Value Planning

Final Report

Elwha River Water Quality Mitigation Project 50-Percent Concept Development

November 14, 2000

Figure 3. Concept Alternative 2

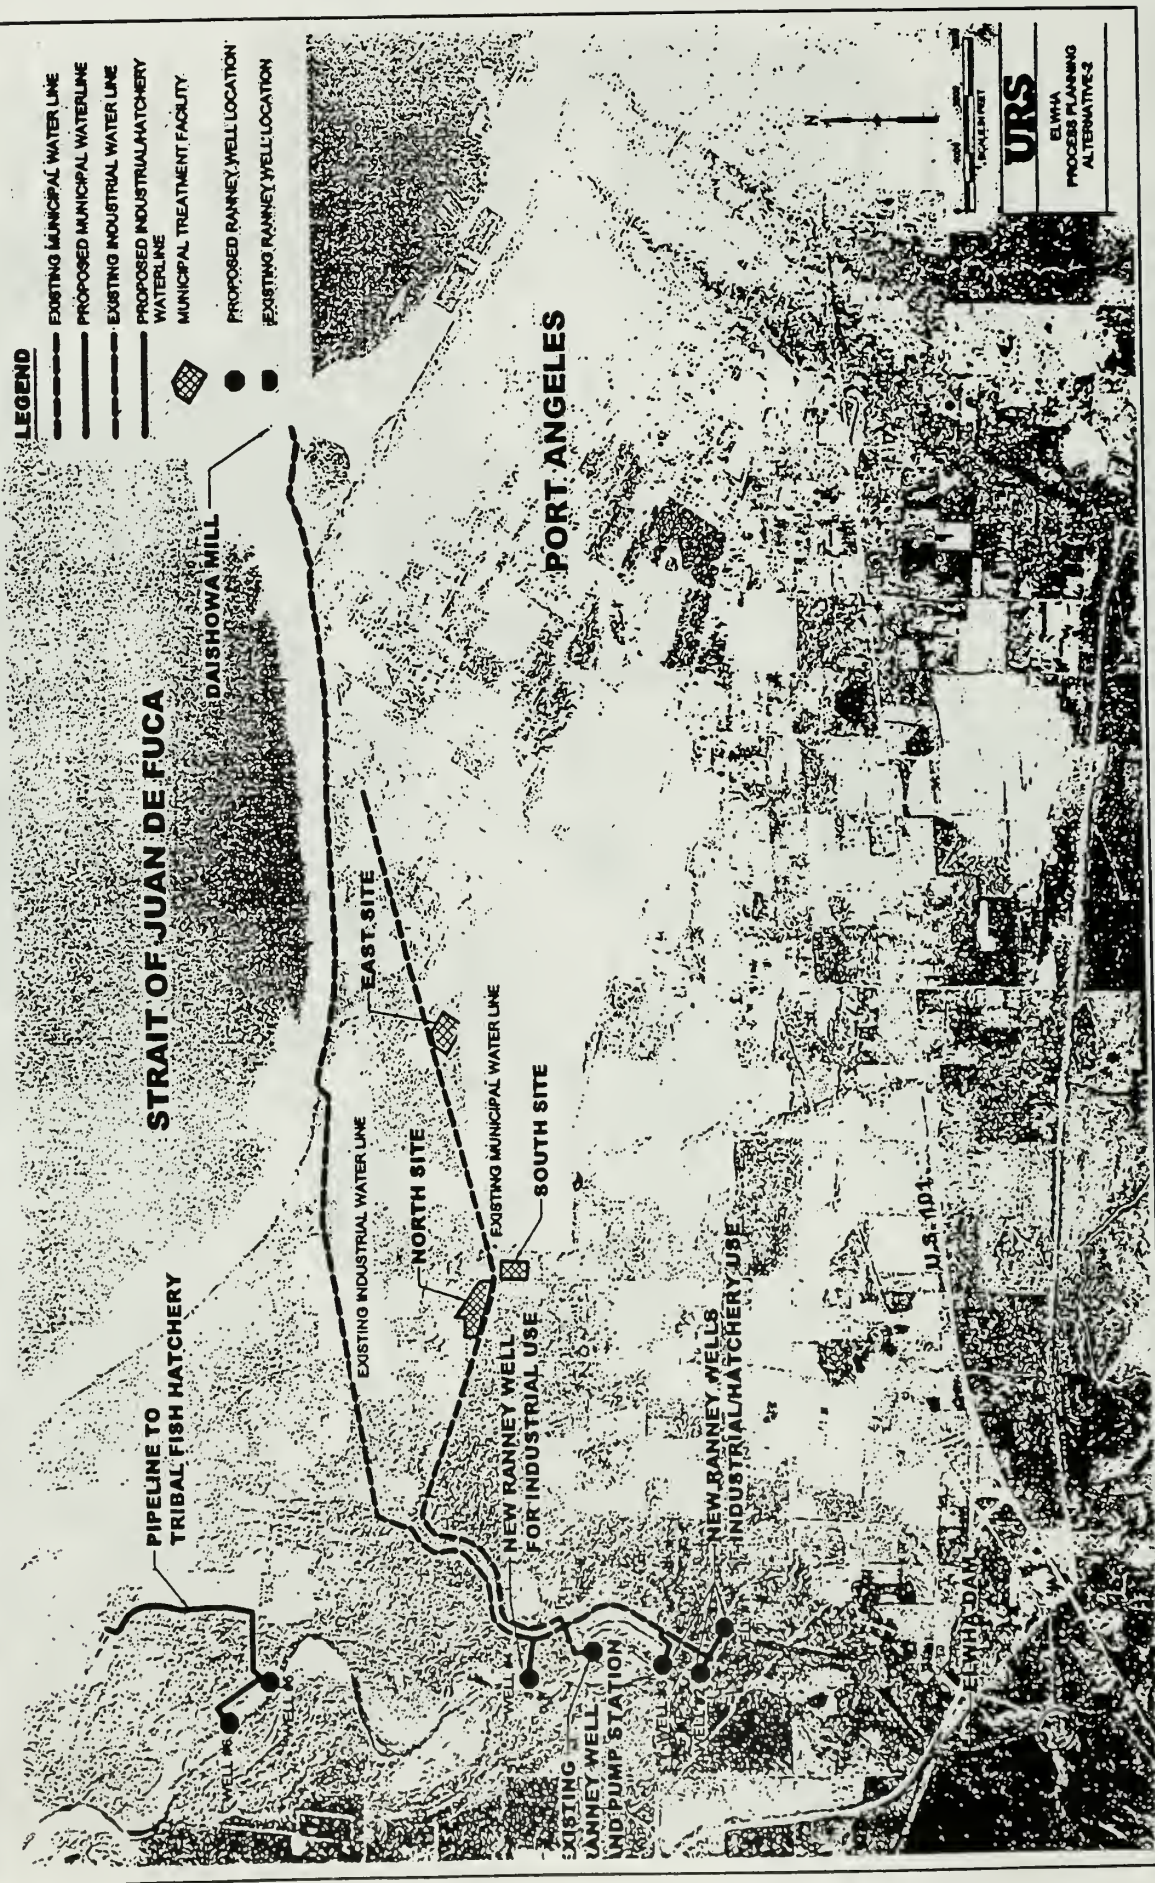
- Proposal Description: This proposal is closely tied to Proposal Nos. 5 and 7. Locate the first Ranney well to be installed at the location of Well No.3, shown in Figure 3. In the DEWQM report, this location is about 1000 feet upstream and on the same side of the river as the existing Ranney well. Production of the existing Ranney well should be closely observed before and after inception of operation of Well No. 3.

- Changes from the Baseline Concept: In Alternative 2, the DEWQM report proposes installation of six Ranney wells. The locations are indicated in Figure 3. The design document does not specify the sequence in which the Ranney wells are to be installed.

- Ways to Implement: Require the construction contractor to install Well No. 3 first, then after well construction operate both wells to determine if one well affects the other.

Figure 6. Typical Water Demands

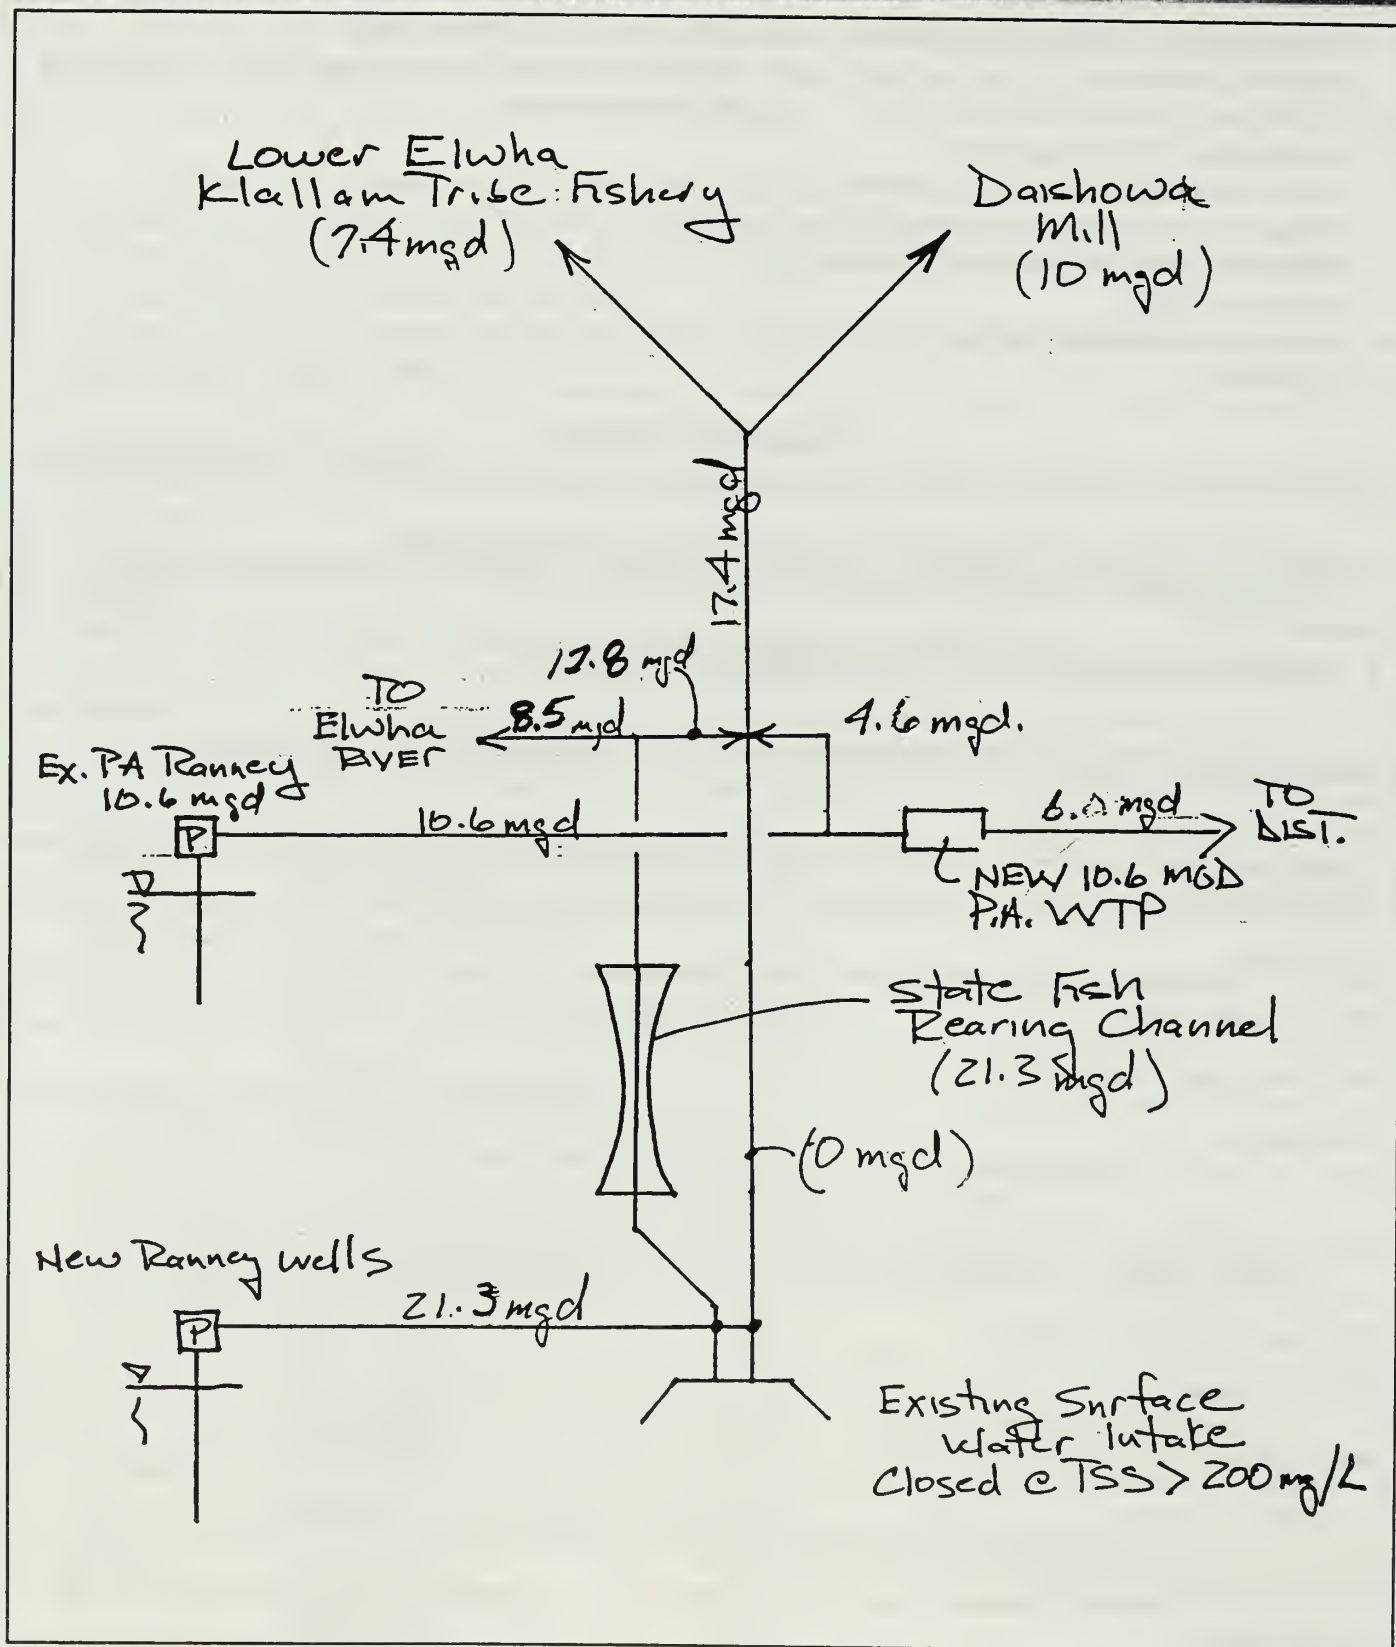
Scenario 1 - Typical Demand Water use under this operating strategy would be as follows (and as shown in Figure 6):

1. The City would use 6.0 mgd of the existing Ranney well production with the remainder or 4.6 mgd added to the industrial supply
2. The two new Ranney wells would produce 21.3 mgd which would be used by the State hatchery. The State Hatchery would send 12.8 mgd of effluent to the industrial supply and the remaining 8.5 mgd discharged would be sent to the River.
3. The hatchery effluent would be diluted with 4.6 mgd excess from the existing Ranney well. This total (12.8 + 4.6 mgd) amounts to 17.4 mgd to be split with 7.4 mgd to the Tribal hatchery and 10 mgd sent to the Daishowa Paper Mill.

Figure 7. Minimum Water Demands

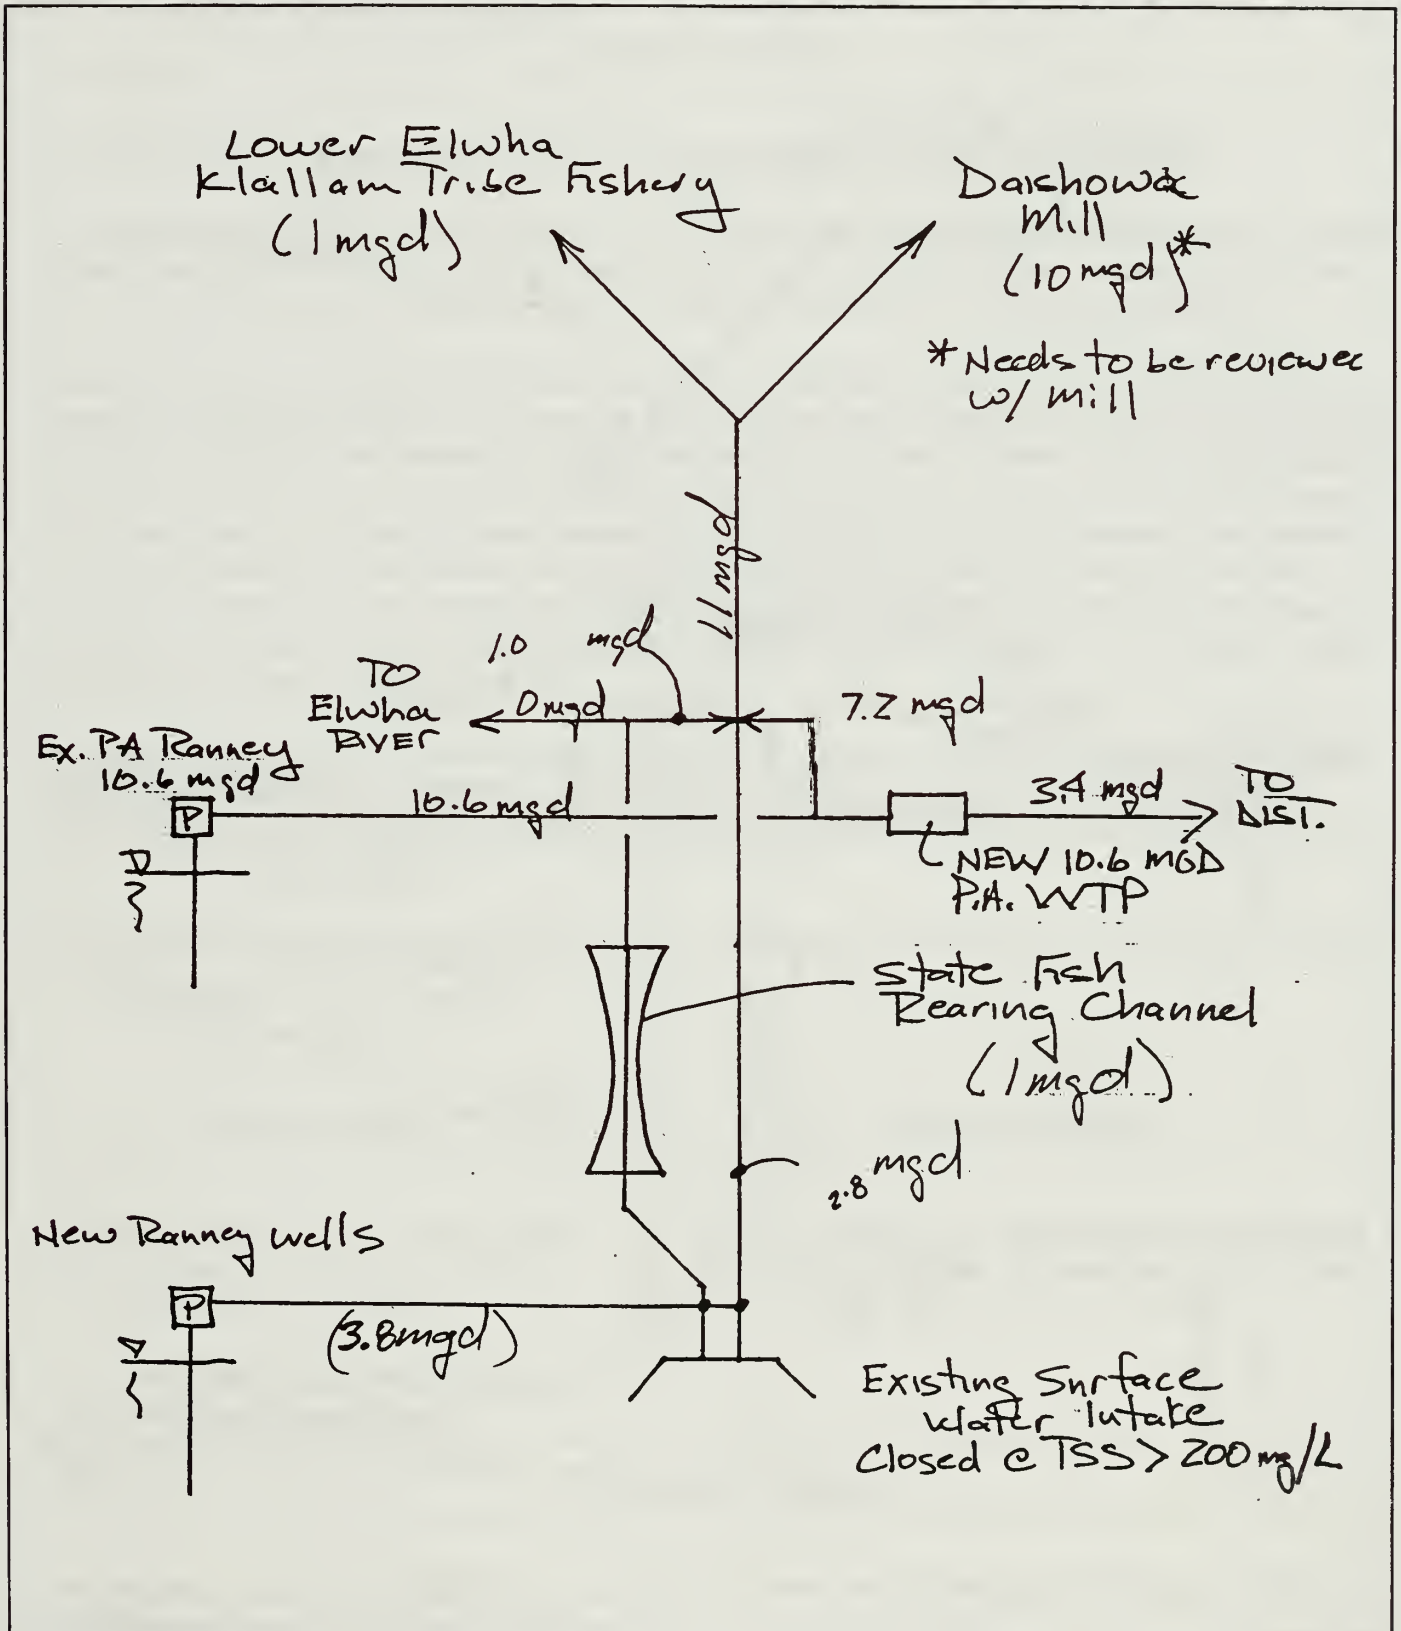
- Similar to Scenario 1, this option uses the same number and types of sources, but the dam is removed in the winter, when the hatchery demands are low. The industrial demand would be less based on the timing for removal of the last 30 feet of the Glines Canyon Dam. The capital cost anticipated for this scenario would be approximately the same as operating Scenario 1. Should this removal occur after the salmon migration season, water demand by the two hatcheries would drop to approximately 1 mgd each. Figure 7 indicates the water balance under operating Scenario 2 (minimum demand conditions) and would be operated as follows:

1. The new Ranney wells would supply 3.8 mgd total, with 1.0 mgd sent to the State hatchery.
2. The excess production from the City of Port Angeles Ranney well or 7.2 mgd would be sent to the industrial demand, along with all the production from the new Ranney wells would also be sent for the remaining industrial demand. Flow from the new Ranney wells would include 2.8 mgd that is unused, and the 1 mgd effluent from the State hatchery.
3. The 11.0 mgd remaining industrial demand would consist of 10 mgd to Daishowa and 1.0 mgd to the Tribal hatchery.

Figure 8. Typical Demands/No Connection

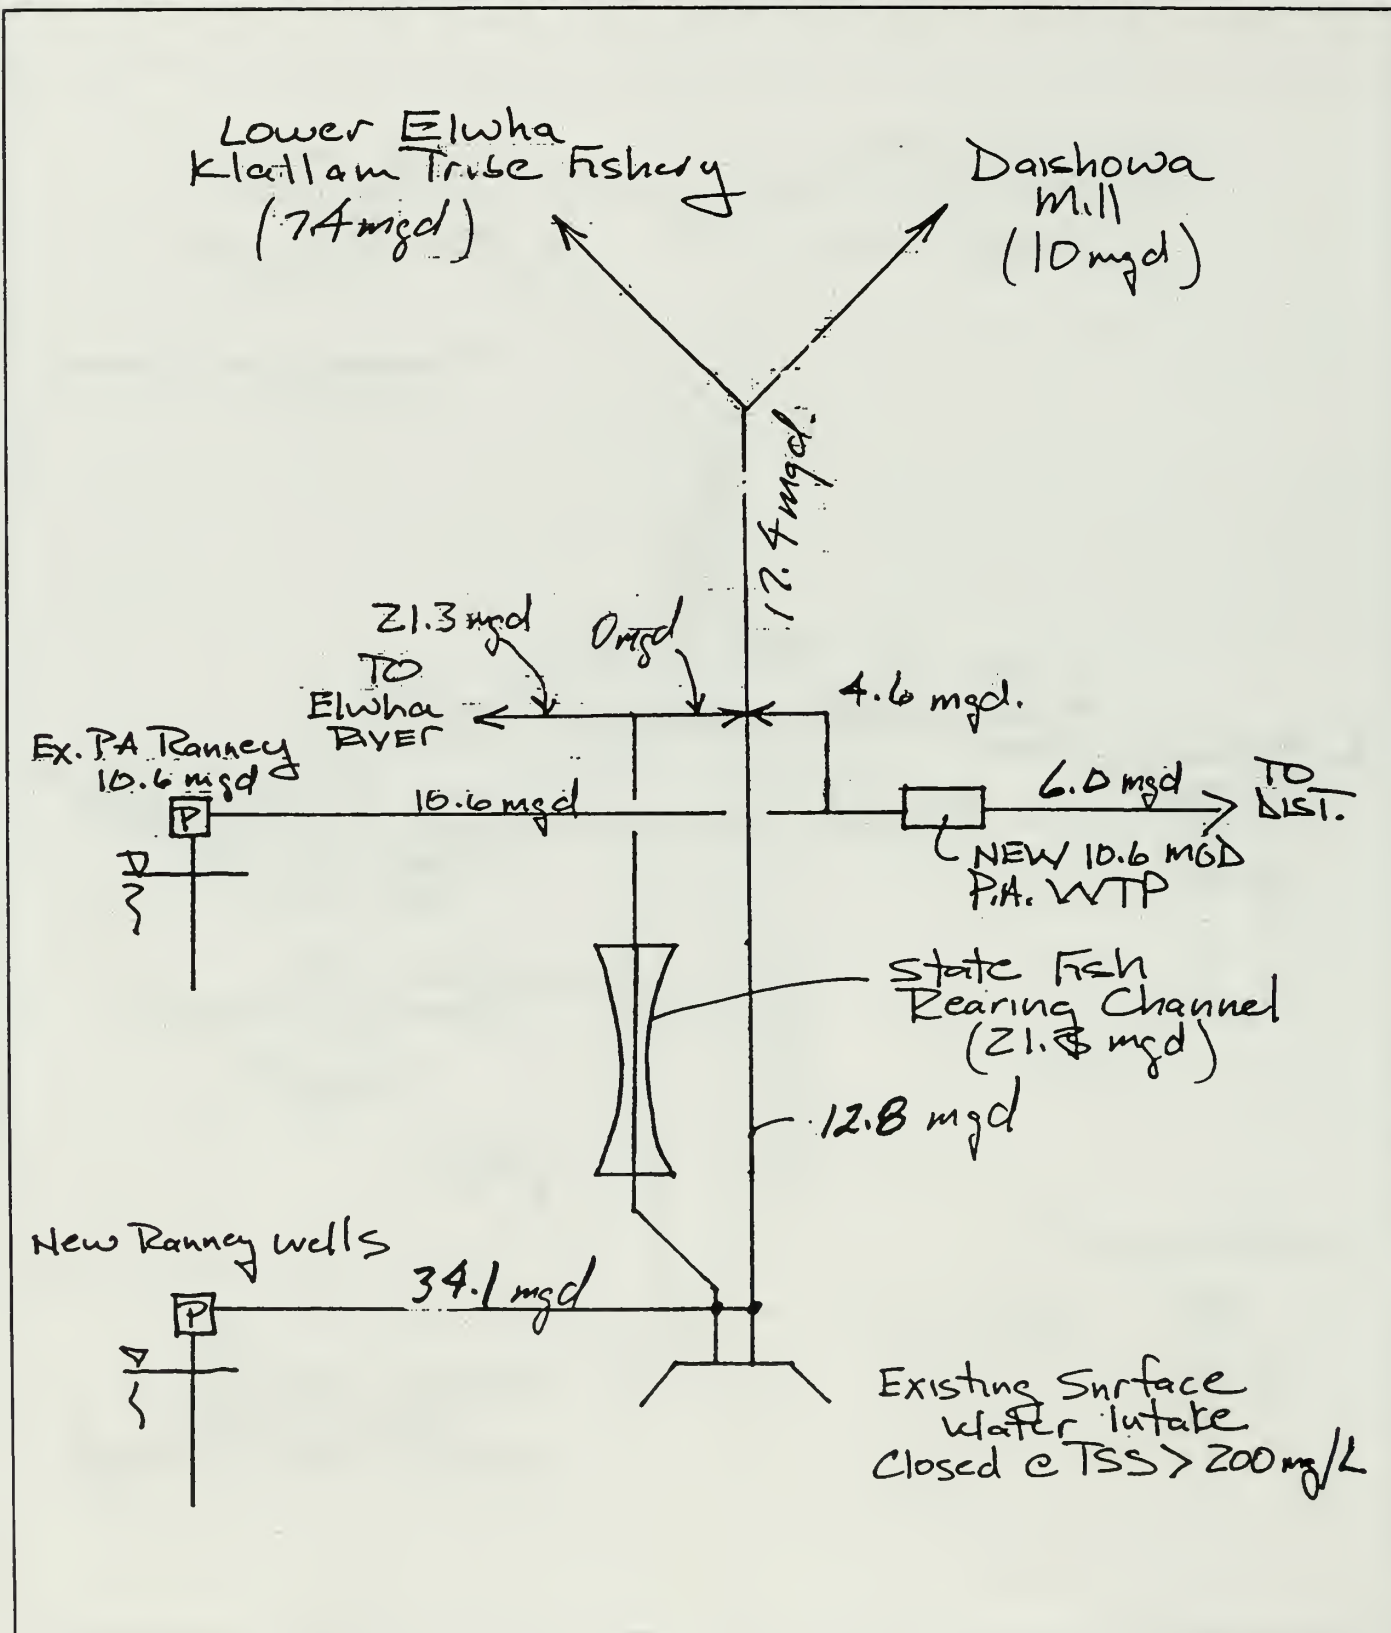
The capital cost anticipated for this scenario would be somewhat greater than for operating Scenario 1. Figure 8 indicates the water balance under this operating Scenario 3 (typical demand conditions) and would be operated as follows:

1. The new Ranney wells would supply 34.1 mgd total, with 21.3 mgd sent to the State hatchery, and 12.8 mgd sent to the additional industrial demand.
 2. The excess production from the City of Port Angeles Ranney well or 4.6 mgd would be used to augment the industrial demand.

3. The 17.4 mgd remaining industrial demand would consist of 10 mgd to Daishowa and 7.4 mgd to the Tribal hatchery.
- Critical Items to Consider:
 - Requires River monitoring and communication between system operation and dam removal operations.
